DESIGN REVIEW COMMITTEE

June 18, 2025 6:00 PM

AGENDA

SHEET TITLE:
PROPOSED EXTERIOR
ELEVATIONS

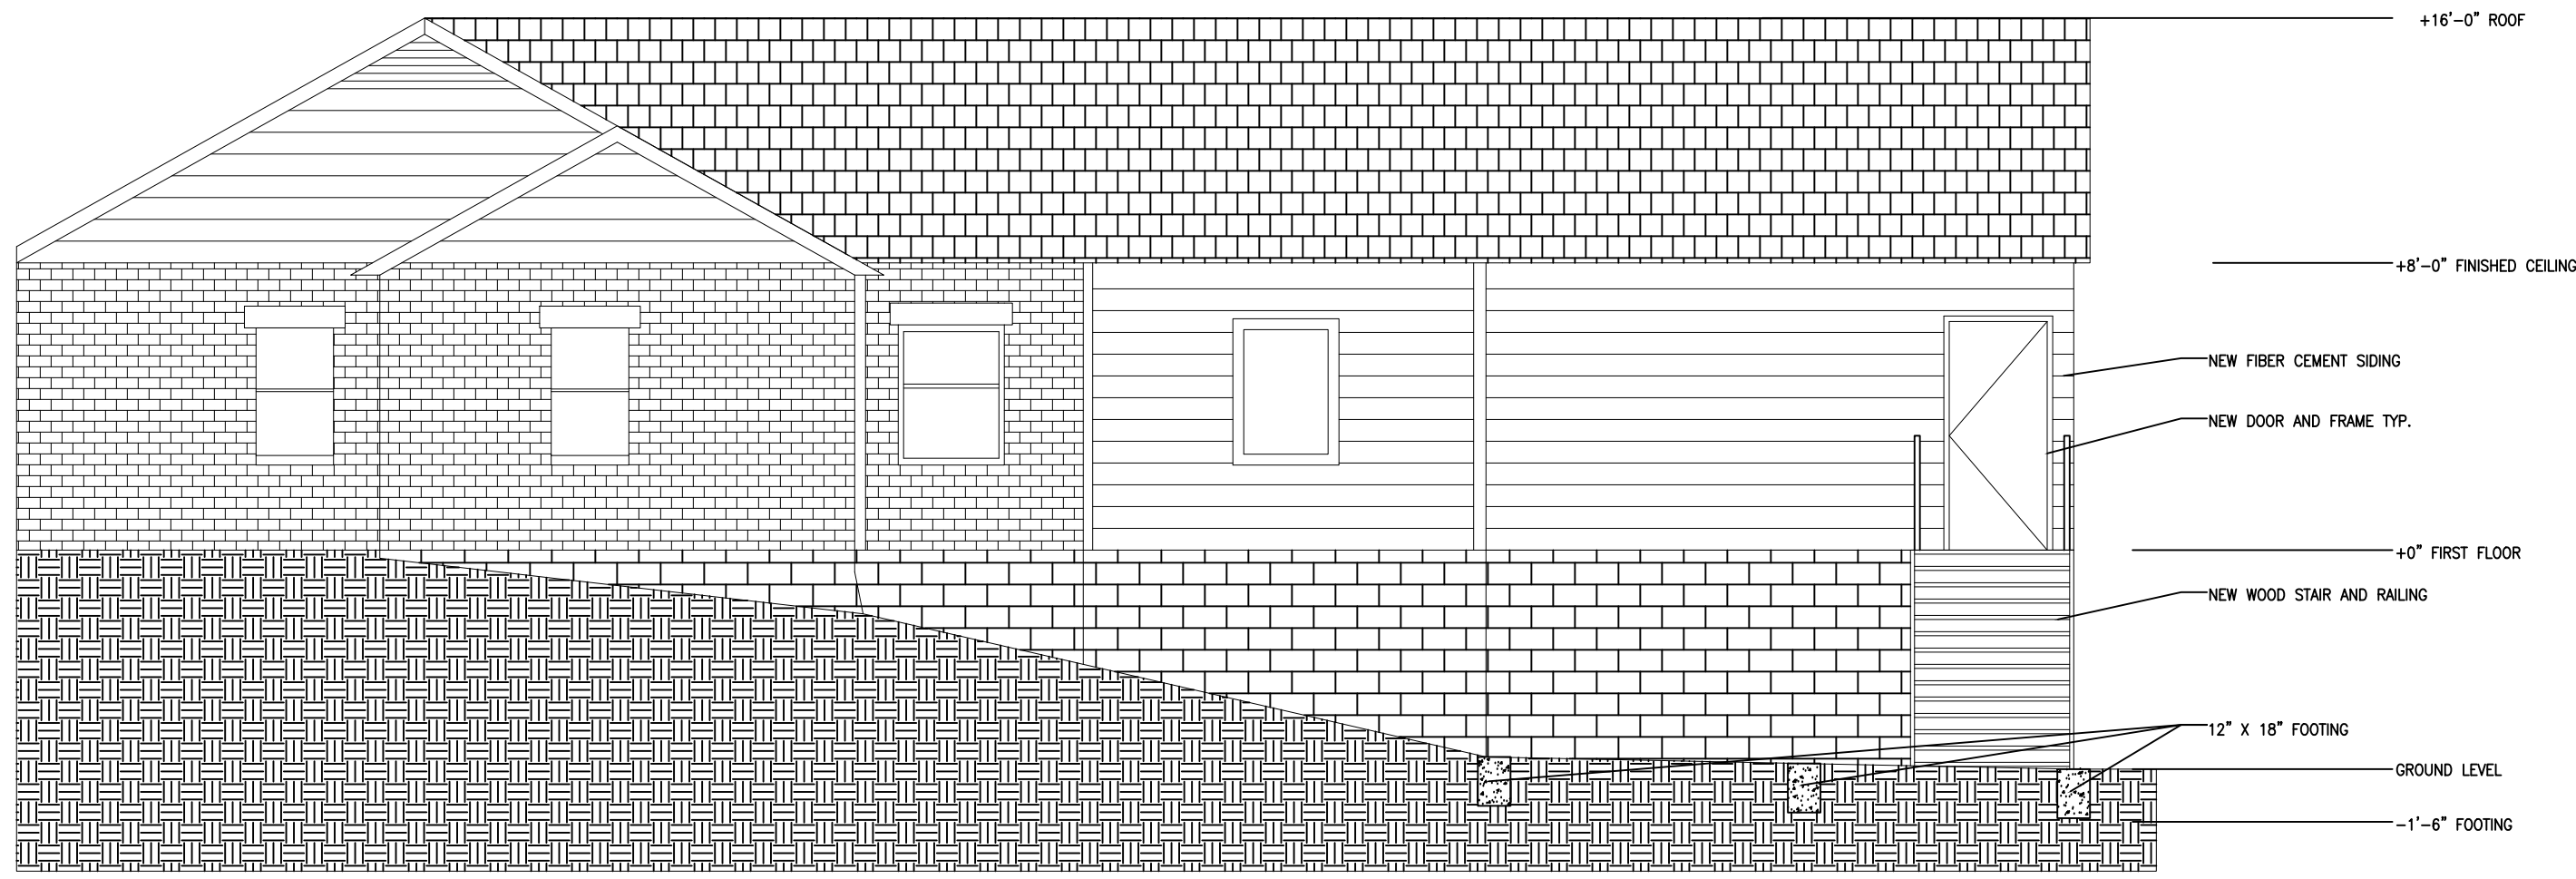
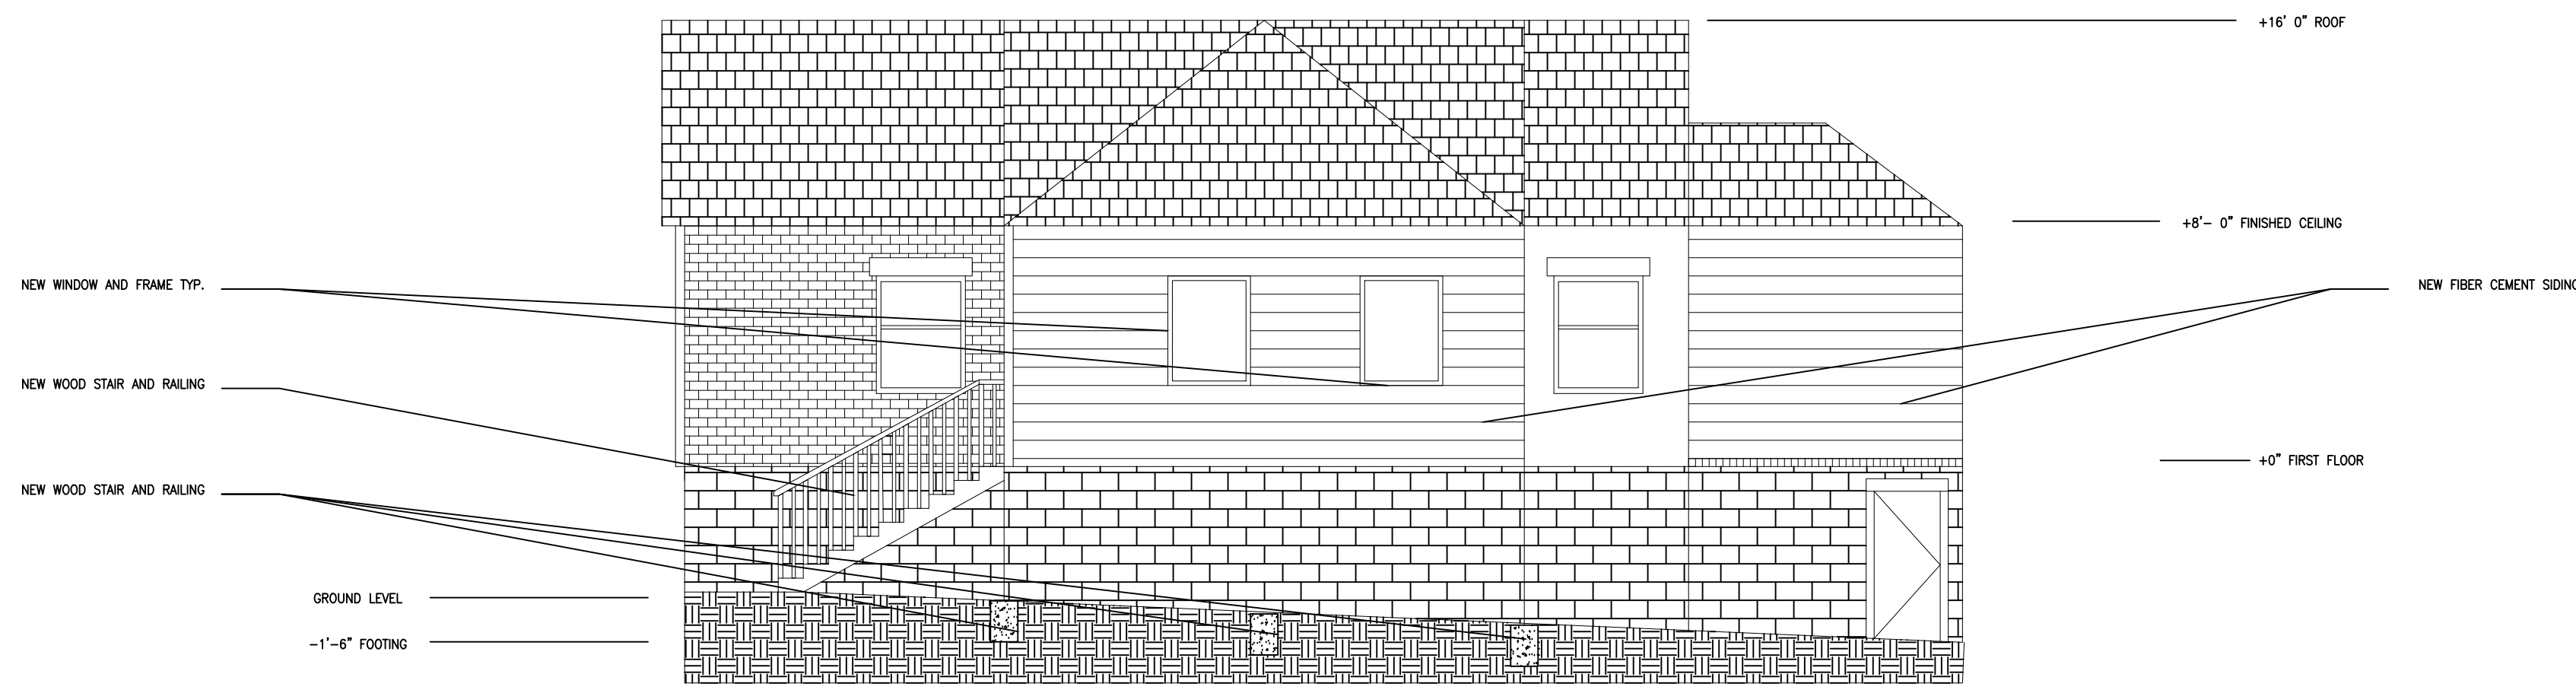
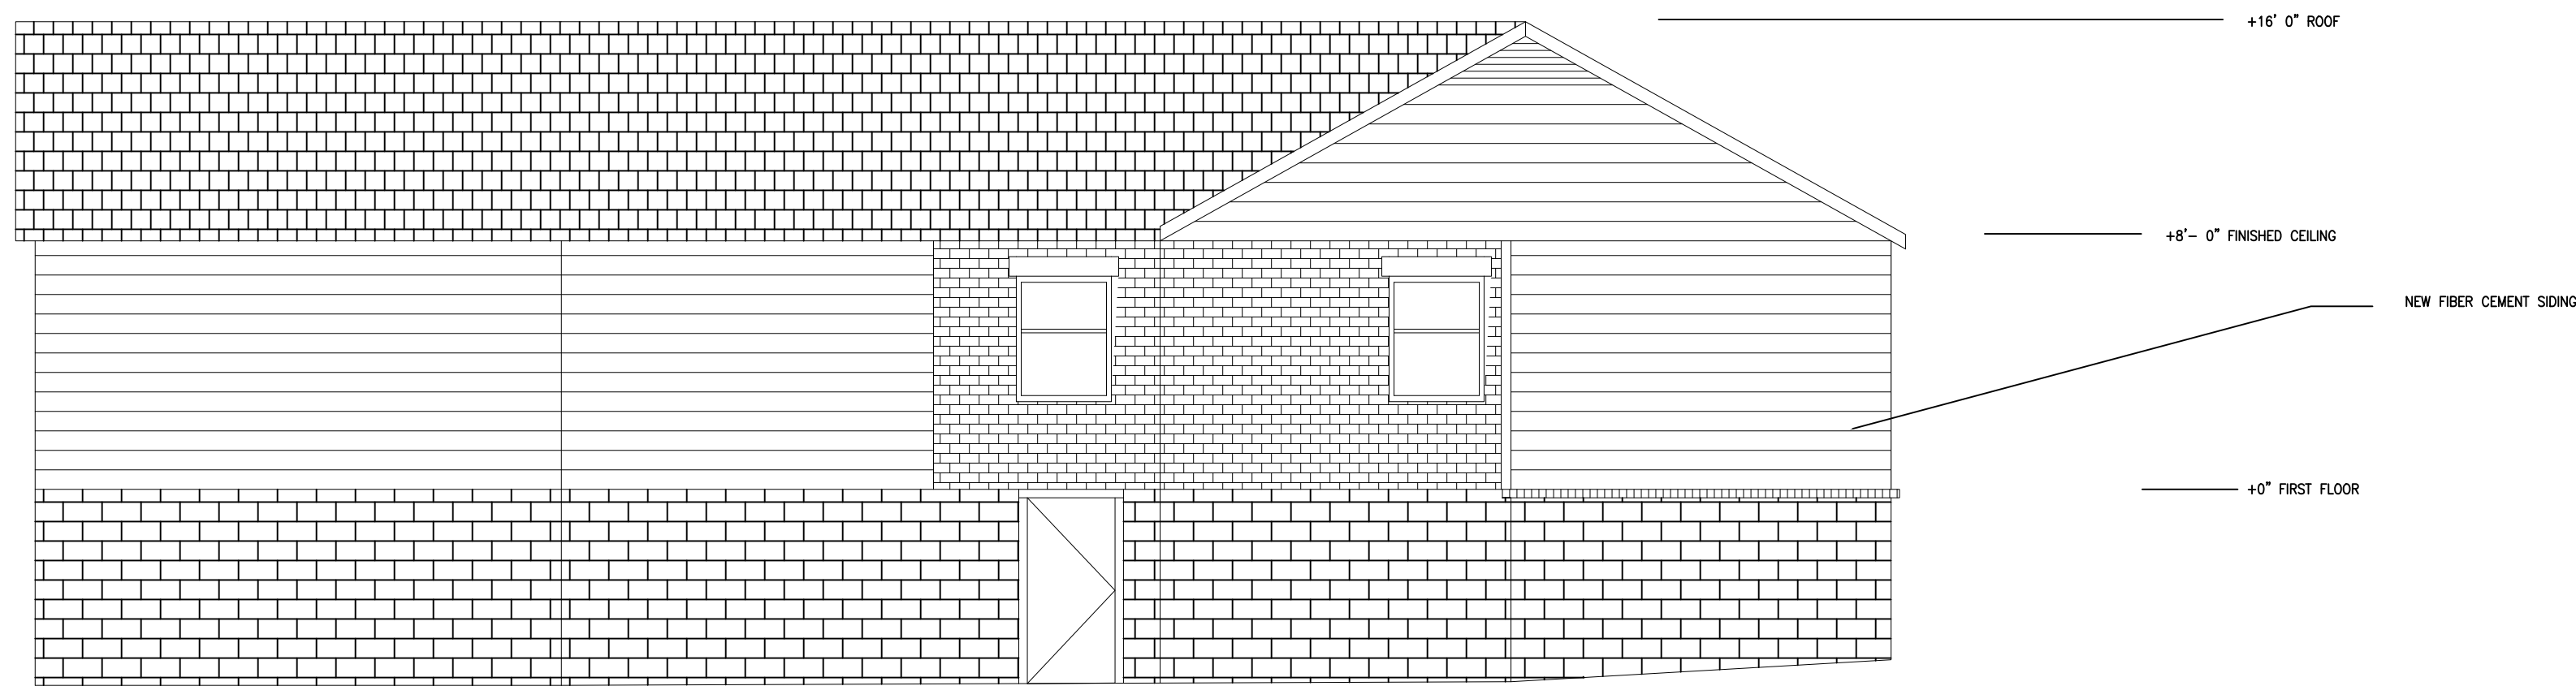
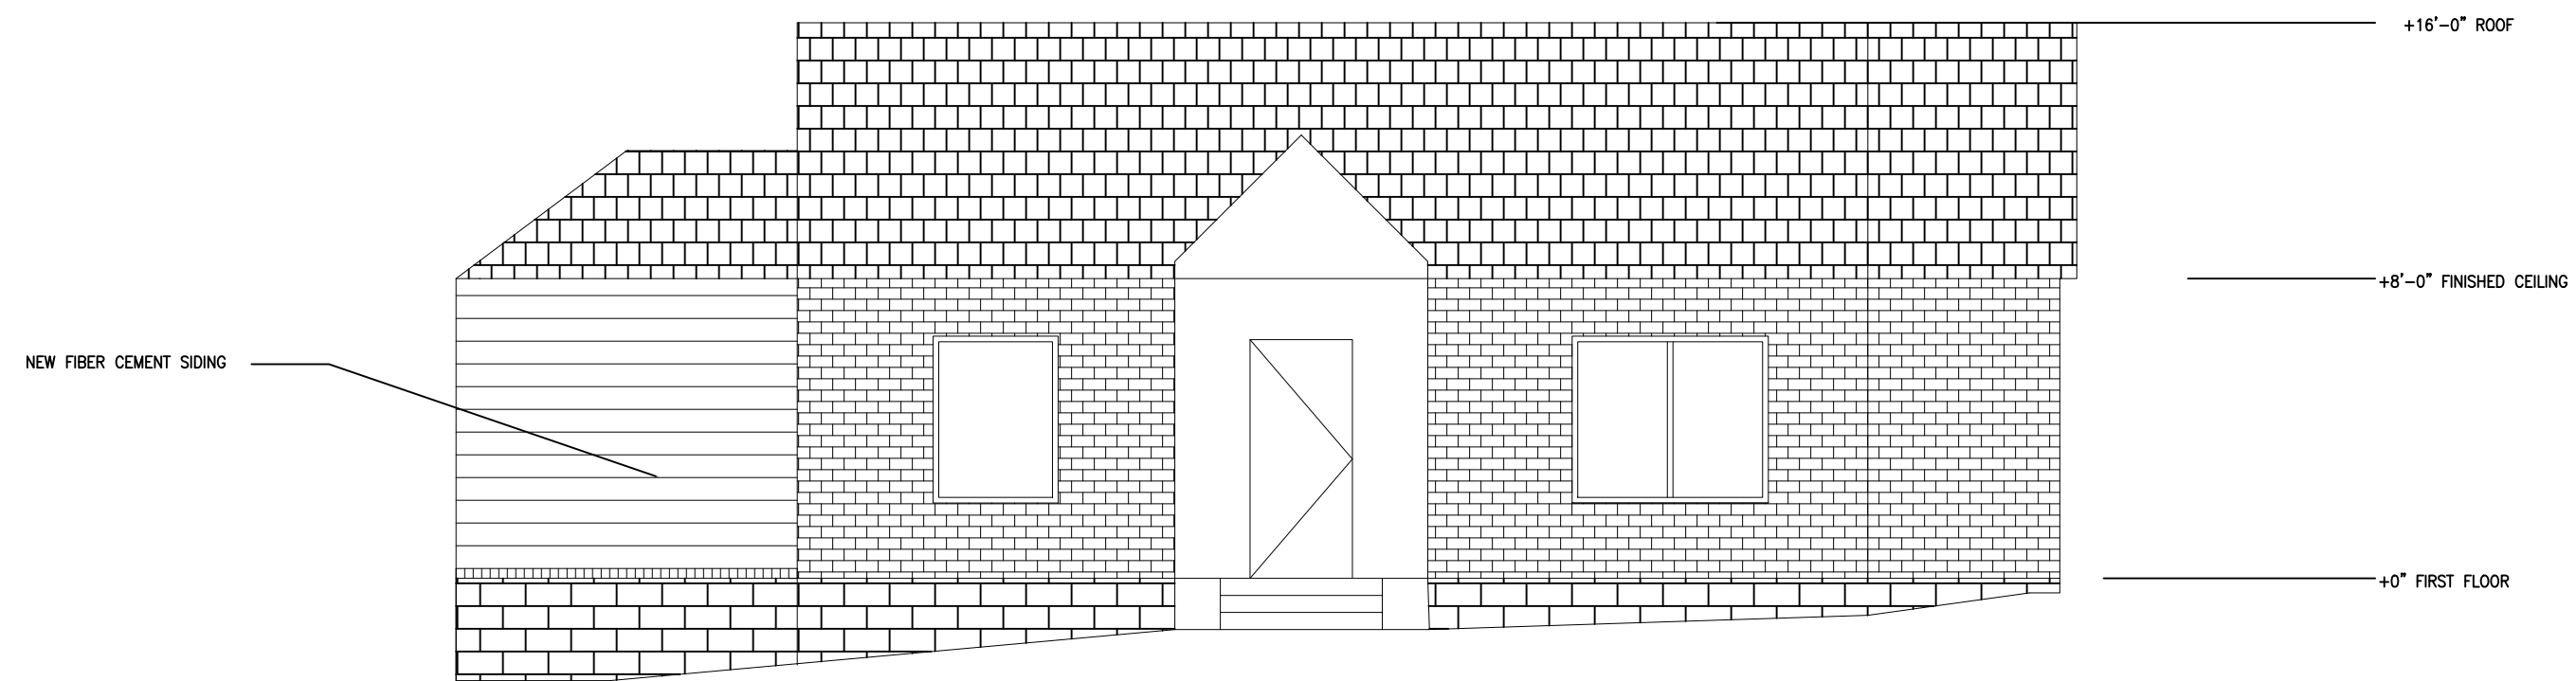
**STAFF COMMENT: Roof Shingles should have a 30 year warranty.
Roof overhang dimension not provided.**

STAFF COMMENT: Please verify the painting or staining of the stairs. The railing shown for the stairs does not meet the standard.

STAFF COMMENT: Window recess should be provided and meet the 2" minimum recess. Fenestration percentage calculation should be provided as the side porch enclosure does not include a window. No trim or sills are shown on the drawings, please provide as required by standards.

- Roof Shingles should have a 30-year warranty. Please call out on plans.
- Roof overhang dimension should be provided. Unless matching existing (with approved Design Exception), overhangs should be 1'.
- Window recess of at least 2" should be shown on plans.
- Fenestration percentage calculation should be provided.
- Trim detail should be provided and meet requirements.
- Distinct sills should be provided.
- Verify the painting or staining of the porch.
- Railing does not meet standard. Please revise.
- Provide height of accessory structure.
- DRC should decide if design of accessory building is compatible with principal structure.
- Applicant should schedule inspections to comply with accessory structure zoning code regulations.
